Town of Lexington
Department of Public Works
Engineering Division

January 22, 2016

This memo is to serve as a response to questions that were left unanswered at the meeting of January 19th as well as additional information as a point of clarification on questions that were outstanding and to provide clarification on other issues.

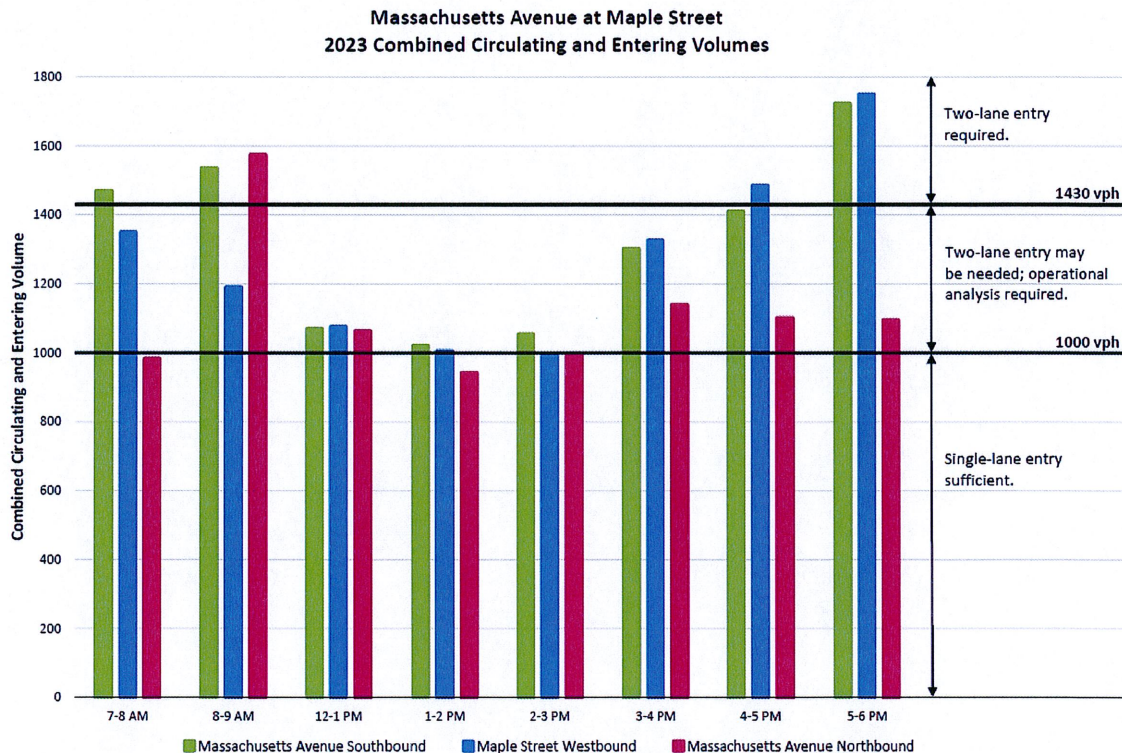
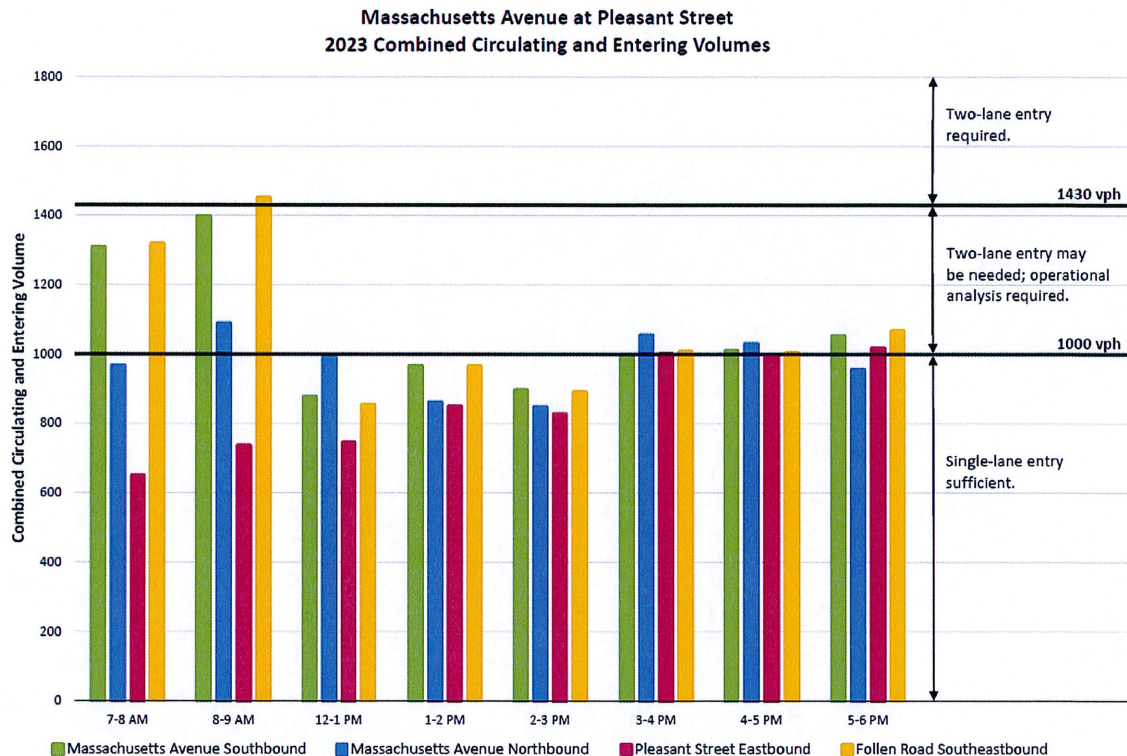
Is the peak hour just one-hour in the morning and one-hour in the afternoon?

The term 'peak hour' defines the heaviest volume hour for the morning and afternoon peaks however there is a span of time both before and after this 'peak' with considerable traffic that impacts the design and recommendation for lane numbers and configurations. We have provided some graphs showing the circulating and entering volumes for both intersections as seen below;

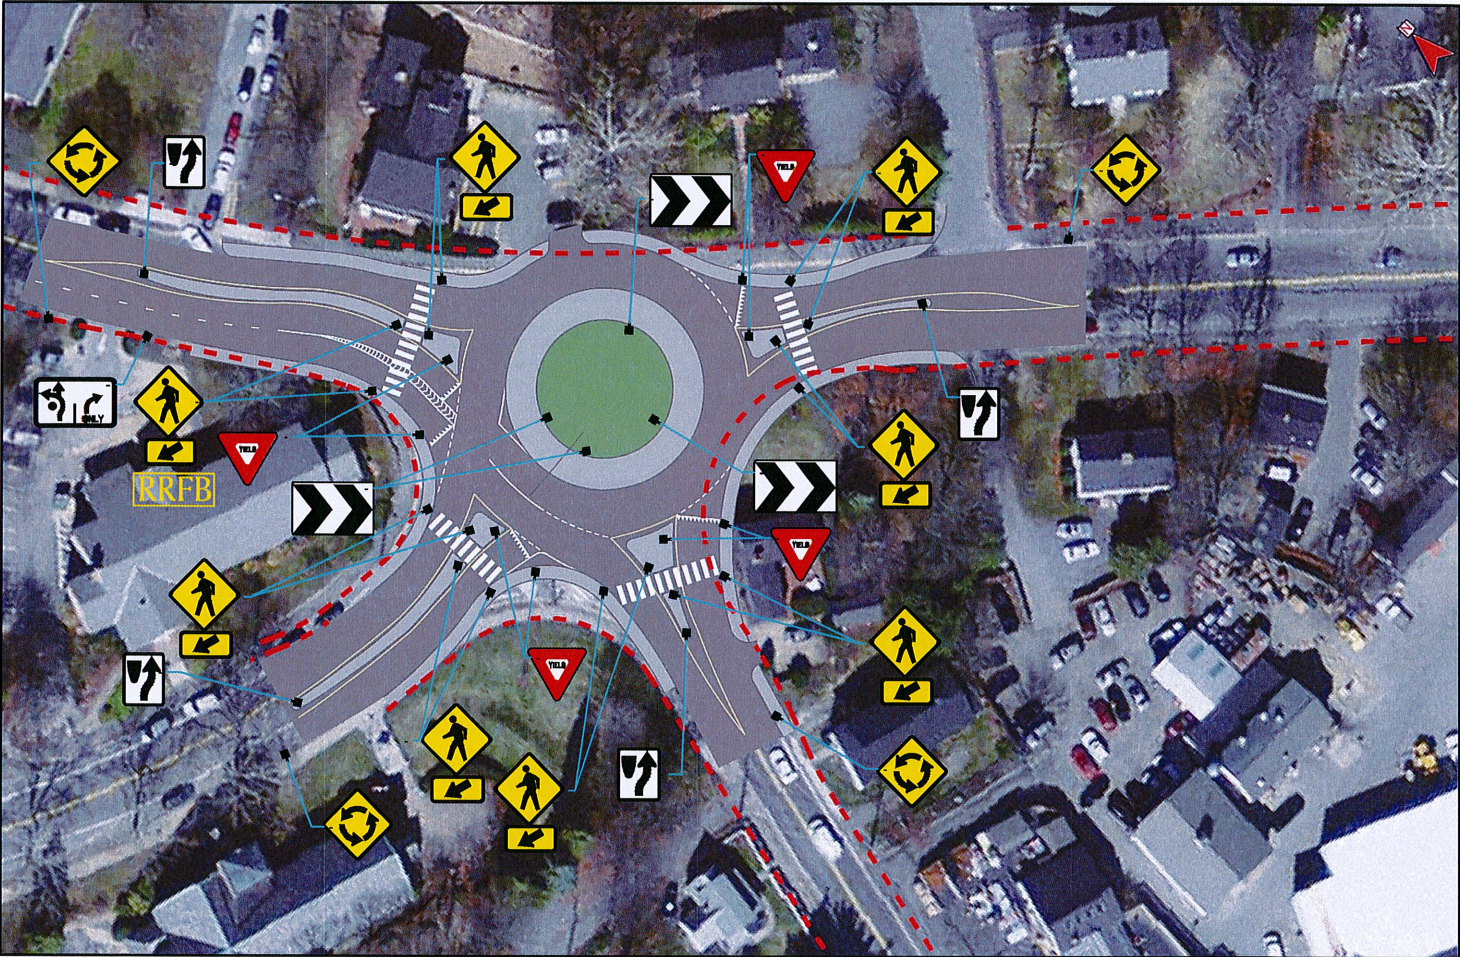
How wide are the sidewalks shown on the plans and what is the width needed if we want a mixed-use path for bike to circumvent the roundabouts?

The sidewalks that circumvent the roundabouts on the plans presented are 6 feet in width. If there is a desire to provide an alternative to bikers to get off the road onto a mixed-use path to avoid taking a lane at the roundabout then the width would need to be increased. The minimum width of a mixed-use path is 8 feet and preferred width is 10-12 feet. This would result in increased impacts and may not be feasible at the Pleasant Street entry onto Massachusetts Avenue due to the proximity of the house. The plans currently show the back of sidewalk approximately 2 feet off the side of the house.

Pleasant Street at Massachusetts Avenue Multi-Lane Roundabout Lexington, Massachusetts

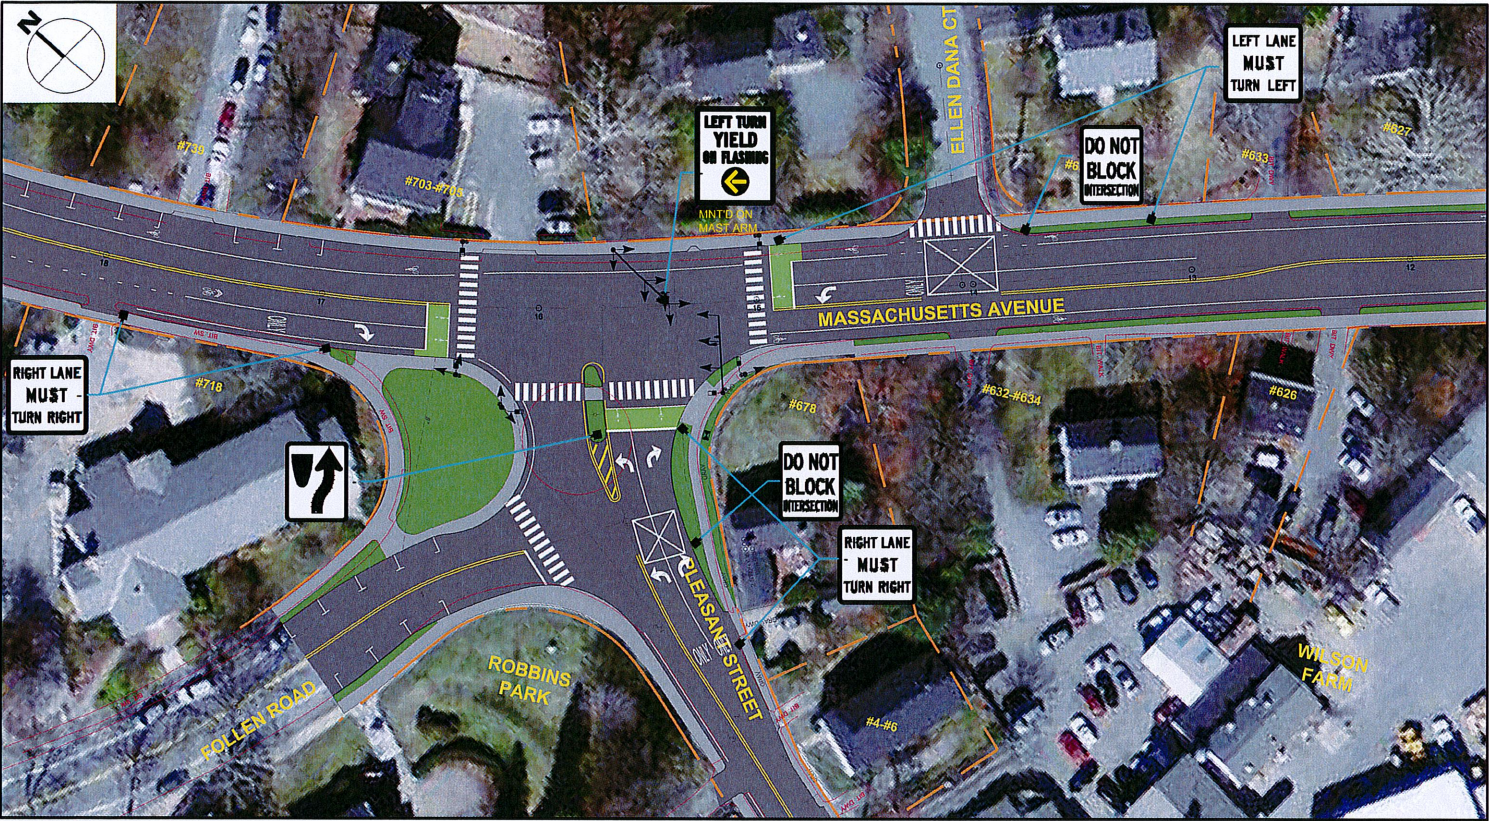
What is needed for signage at the Pleasant Street roundabout?

A member of the Historic Districts commission has asked about the signage that is anticipated at pleasant Street under the roundabout proposal. Following the Manual of Uniform Traffic Control devices (MUTCD) we have put together graphics for both the roundabout and signal alternatives at this location as seen on **attachment 1**;

Proposed Geometry, Pavement Markings, & Signage

Sample of a HAWK installation

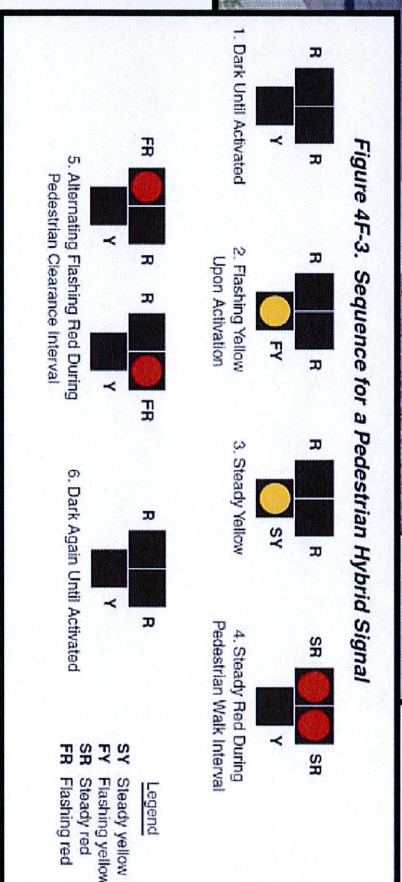
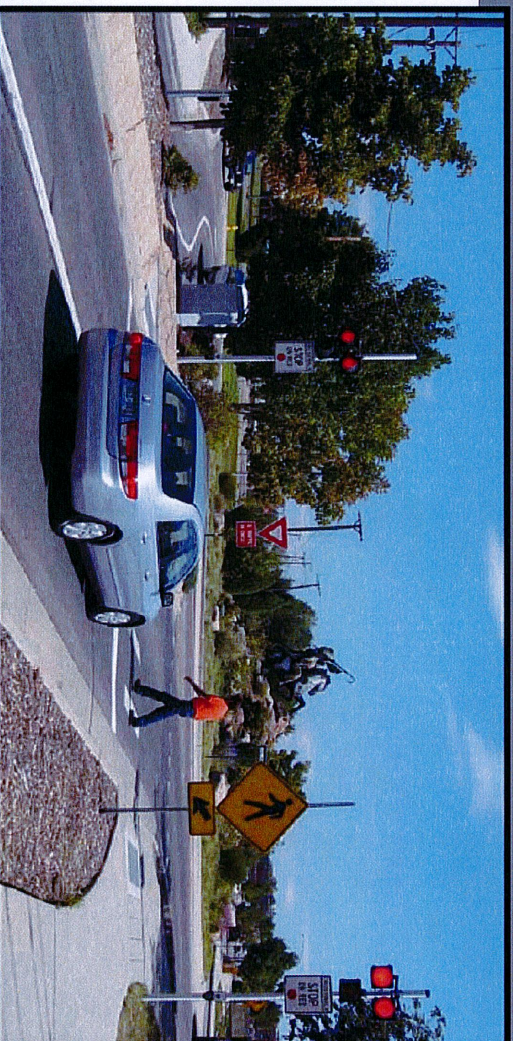
What do HAWKs and RRFBs look like at a roundabout?

We have attached a few photos from locations that these have been installed that we feel are representative. We would recommend decorative poles at the installation locations. Please note that these photos are NOT meant to represent the size and lane configuration of roundabouts, but to convey the general look of the crossing fixtures and signage. **See attachment 2.** We have asked MassDOT if they would require these on overhead mast arms versus the post-mounted version but have not yet received confirmation on there requirements.

100 feet of Granite Block wall needs relocation

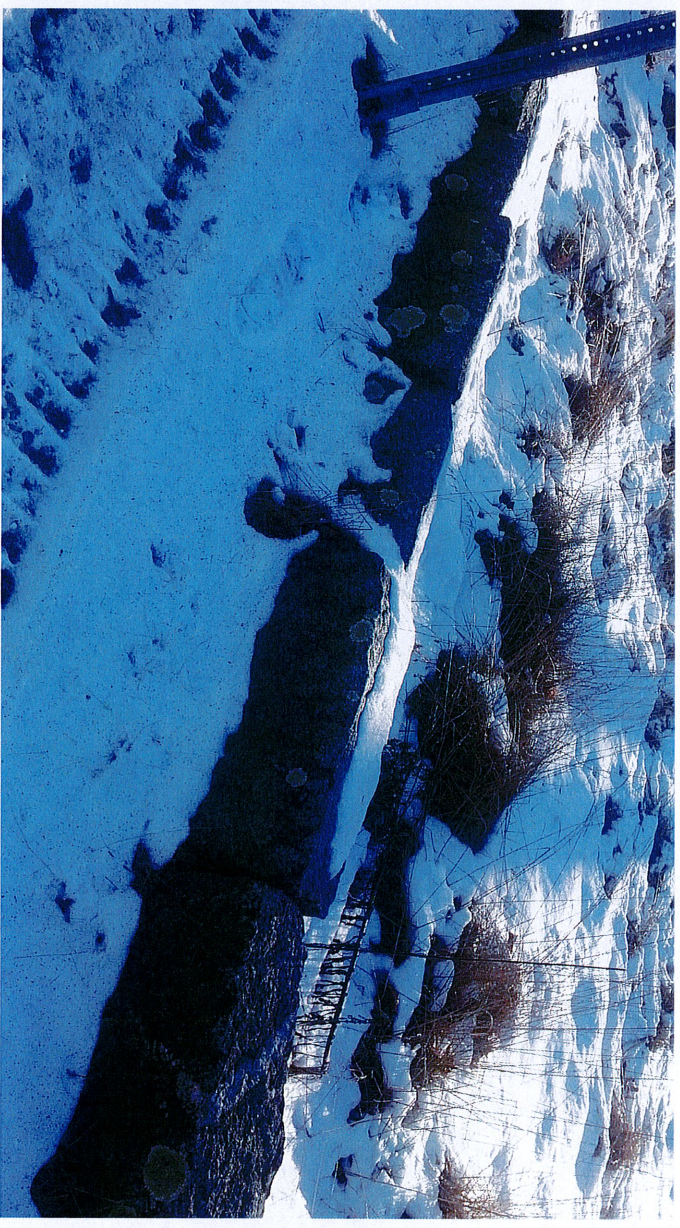
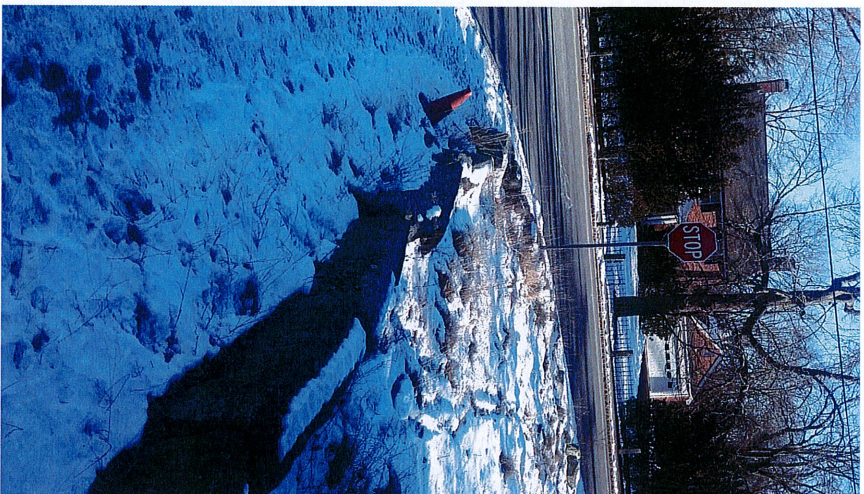
What historic features are impacted at Pleasant Street under the roundabout scenario?

The impacted features are labeled on the plan distributed at the January 19th meeting. We have also taken photos of many of the features to provide a visual as can be seen **attachment 3** and provided approximate lengths of impact to these features. In addition to the items noted on the photos there is also an estimated 5 private trees, 2 private parking spaces (Waldorf property / old general store), and 30 feet of hedge to would need to be removed.

38 feet of fence needs relocation

16 feet of stone wall to be removed
